Planning and Zoning Commission Report

Date: July 26, 2022
To: Planning and Zoning Commission
From: Watkins Fulk-Gray, Senior Planner
Subject: Planning File #54-21– Minor Site/Architectural Plan
175/185 County Road 135

REQUEST	Consideration of a Minor Site and Architectural Plan for two multifamily buildings with a total of 14 residential units.
APPLICANT	Gabriel Molnar and Keith Teahen
OWNER	Moltea III, LLC
LOCATION	175/185 County Road 135 (PIN 2185-052-00-090, 2185-052-32-002)
ZONE	Mixed-Use M1
SURROUNDING LAND USES	North: Residential South: Residential East: Residential West: Residential
LOT SIZE	185 CR 135: 10,148 square feet; 175 CR 135: 20,038 square feet

NORTH
1
PROPOSED LANDSCAPE PLAN
1" = 10'-0"

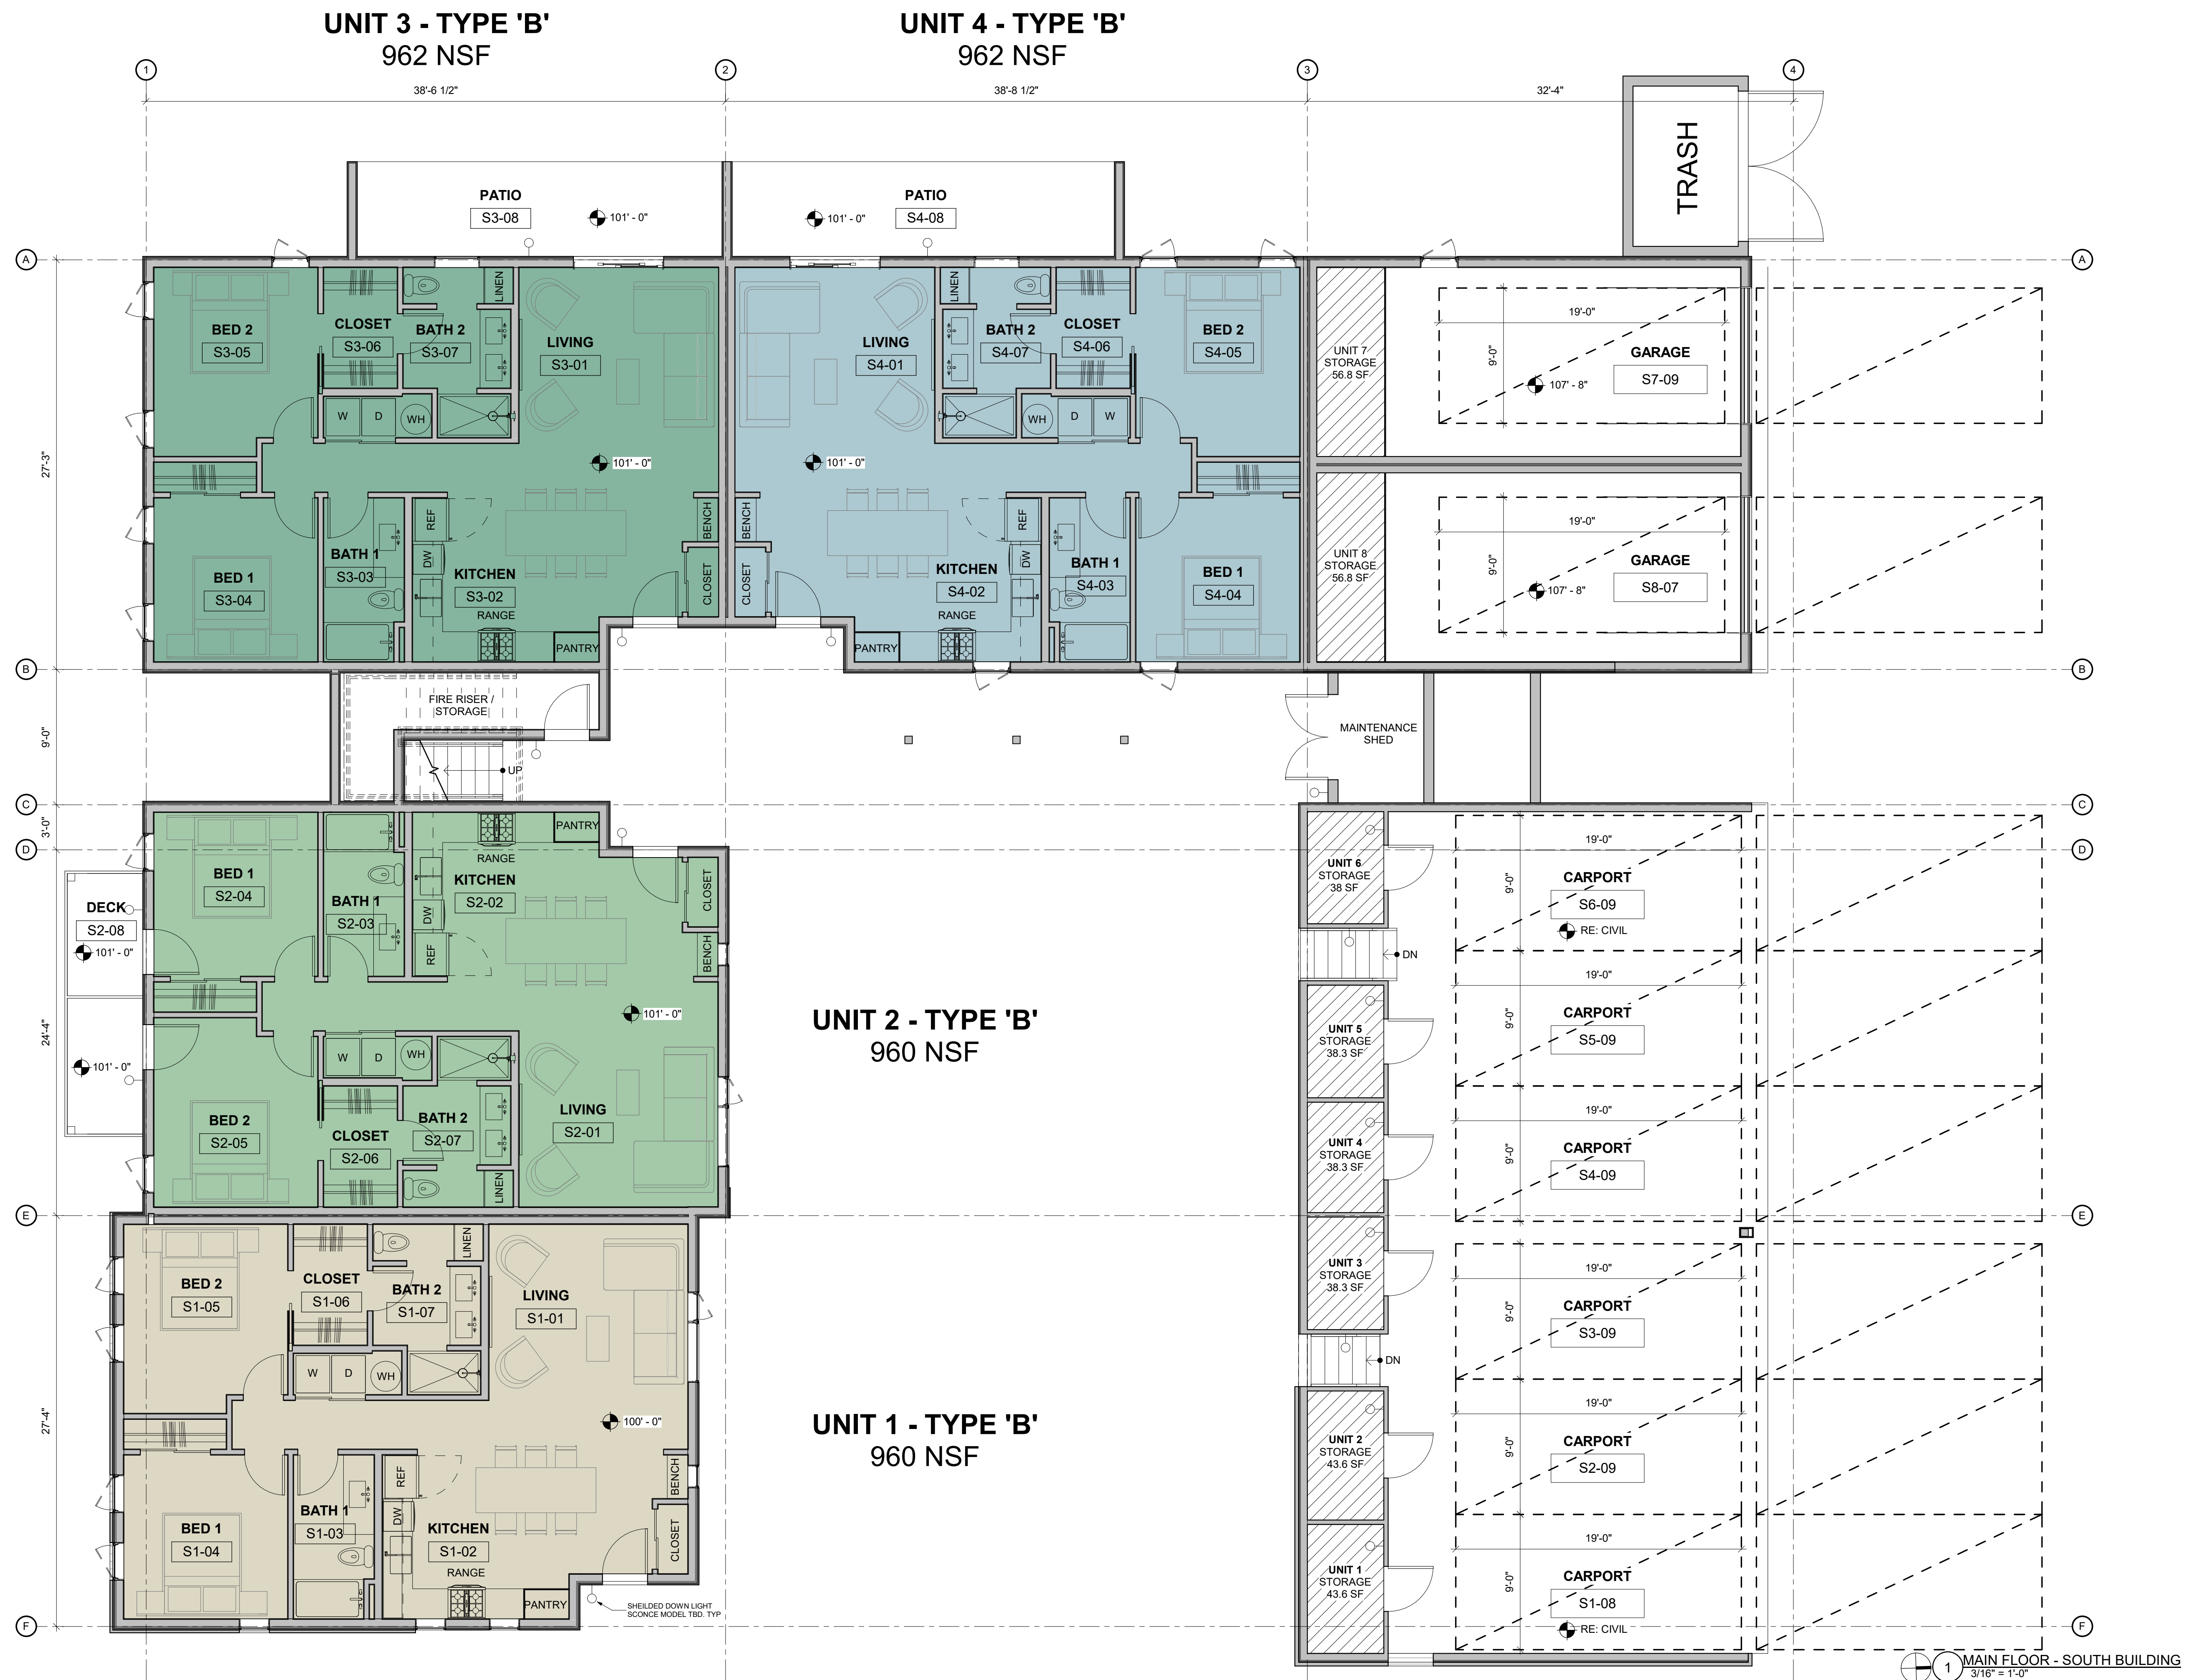
20. As part of Final Plans Review, revise landscaping plan to meet code requirements in the following ways:
 - a. Include the required number of perennial plantings

- d. Include street trees meeting the quantity and location requirements in the development code
 - e. Provide detail about ground cover in between plantings

- f. Include a planting strip in the area shown in the plans as between the front property line and the proposed curb and gutter.
21. The required community housing unit shall be a unit with at least two bedrooms.

1 SOUTH BUILDING - NORTH ELEVATION COURTYARD
3/16" = 1'-0"

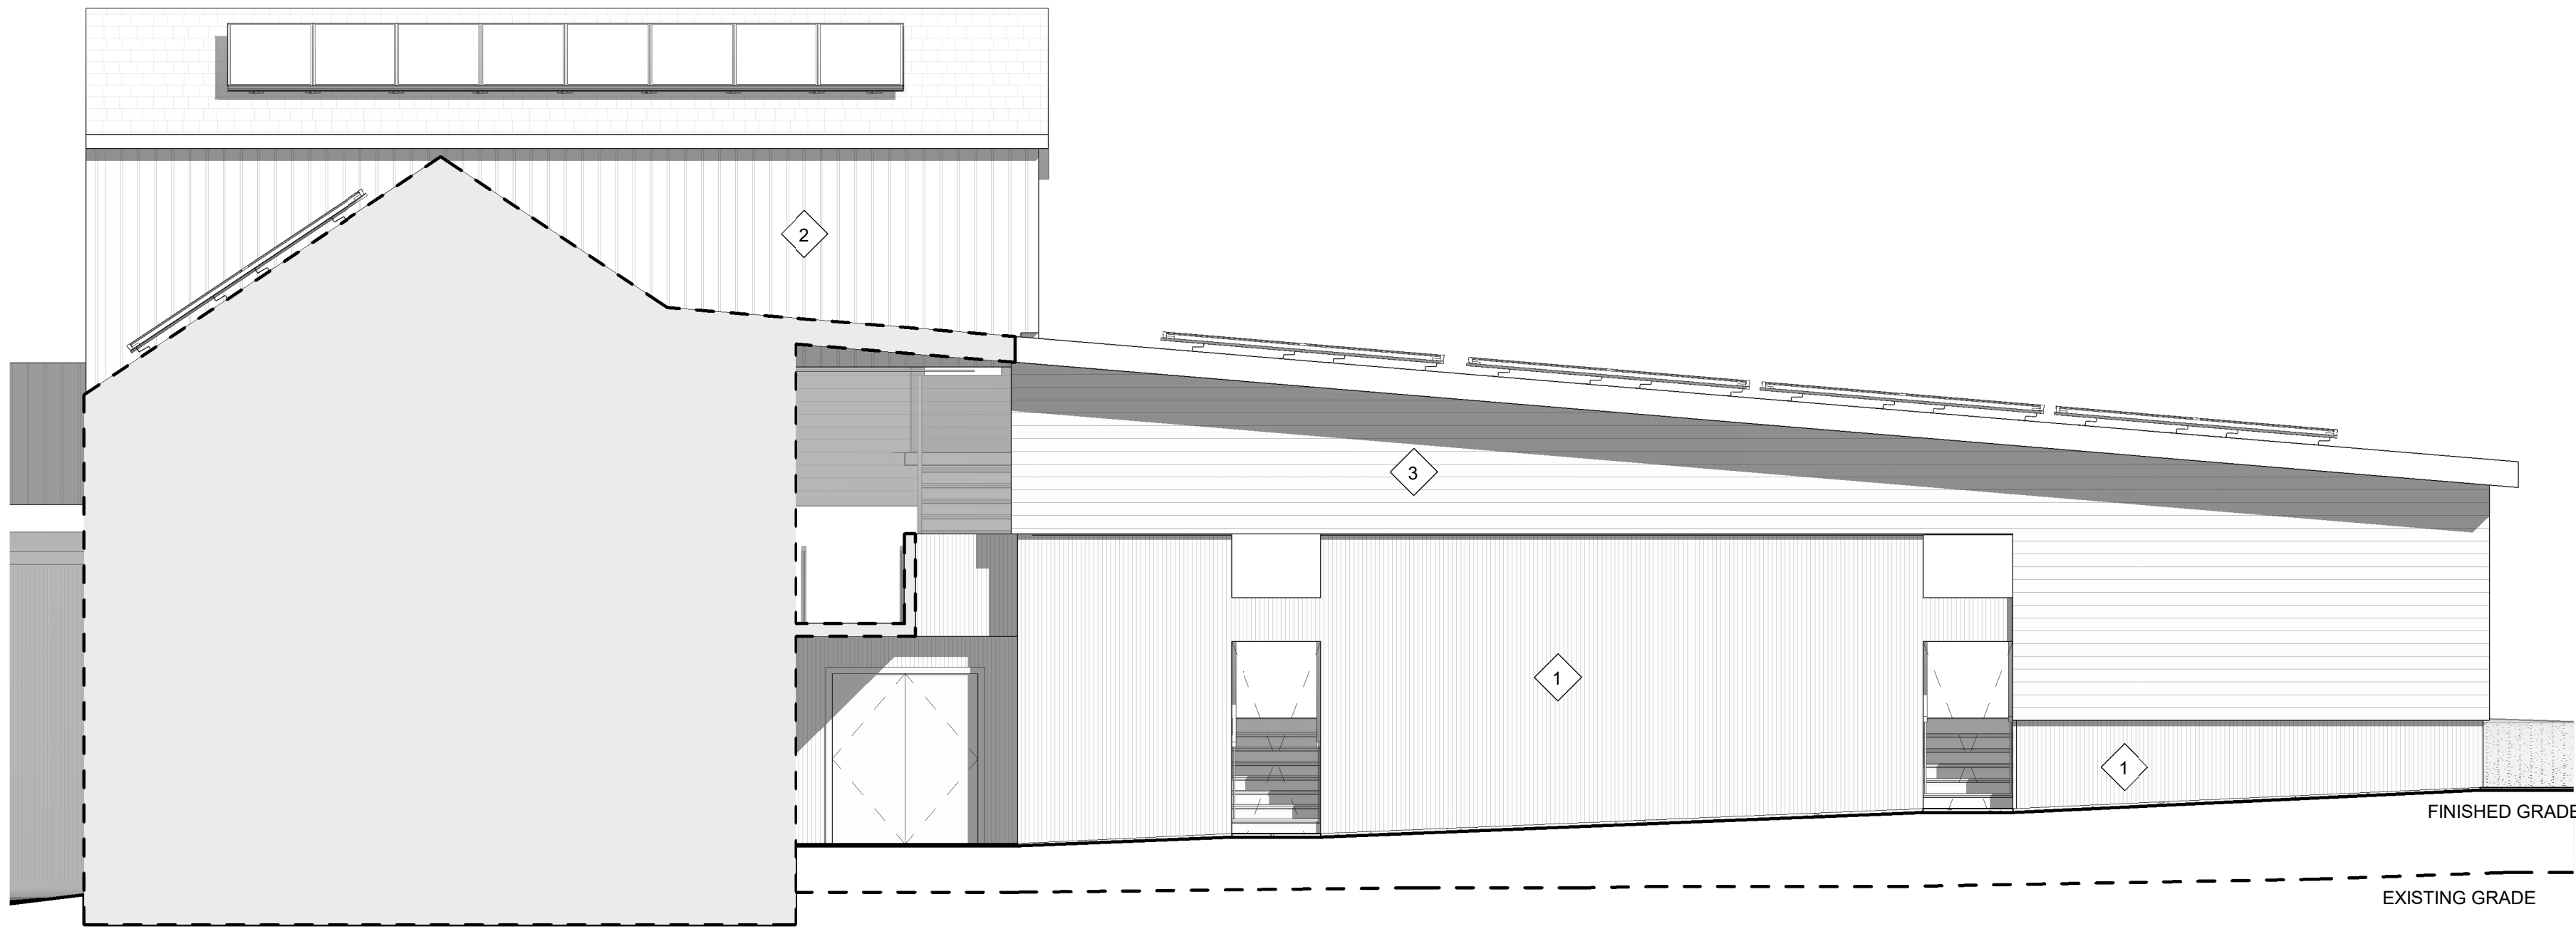
22. The south building's elevation profiles for the south and north courtyard shall be modified to reduce the amount of corrugated metal so as to be an accent material and not a primary material of these two elevation profiles.

Curb & Gutter

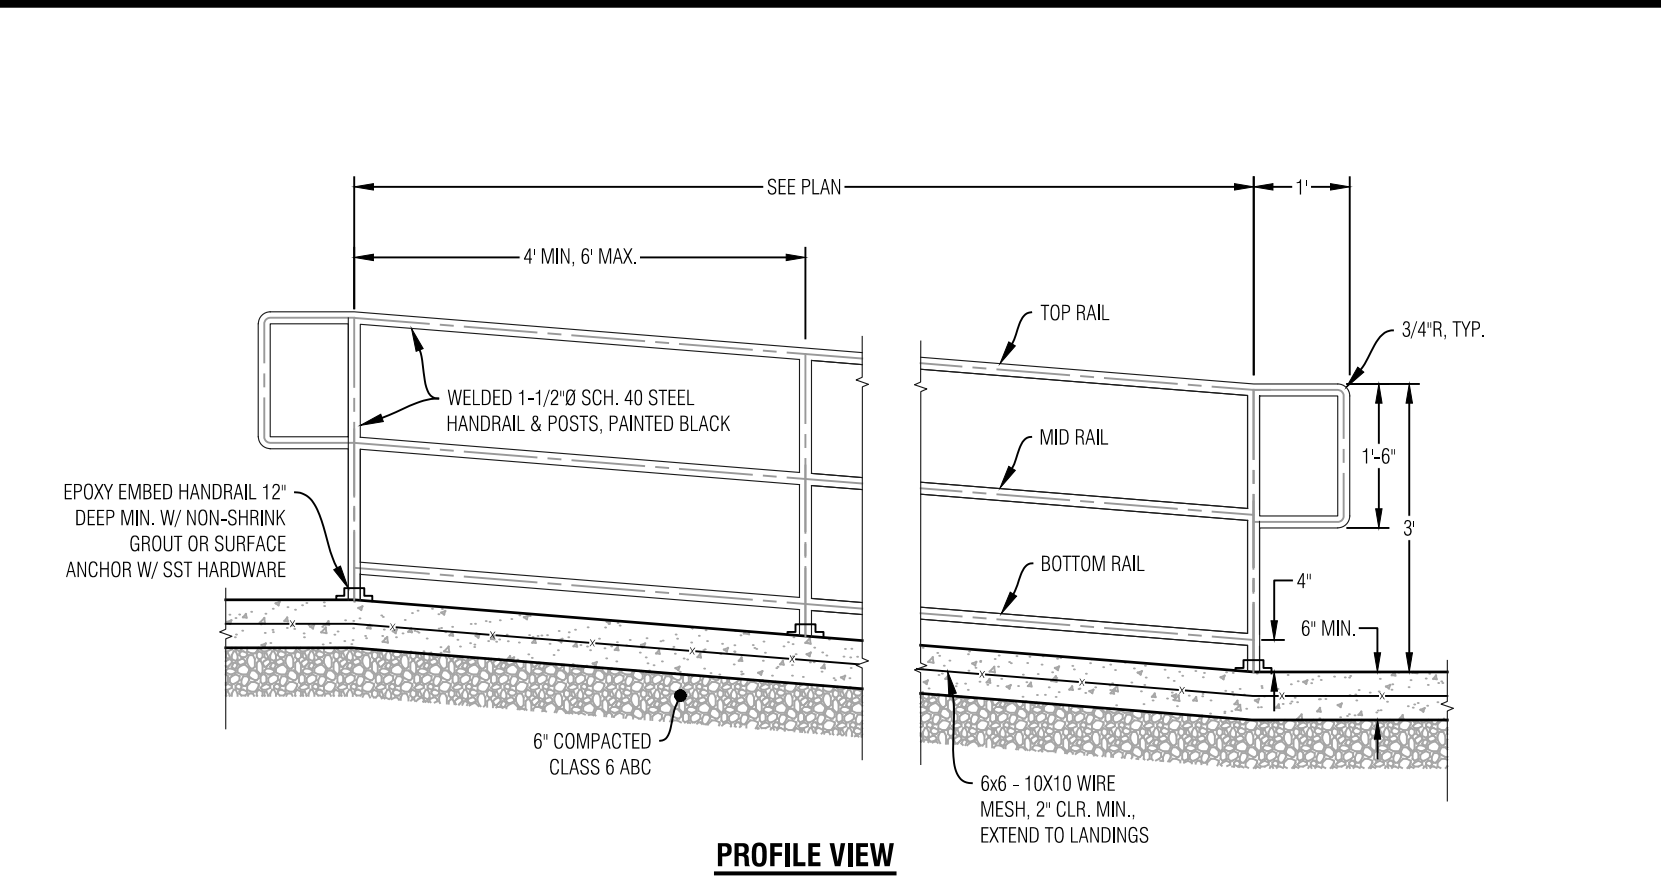
where is mountable curb and gutter detail
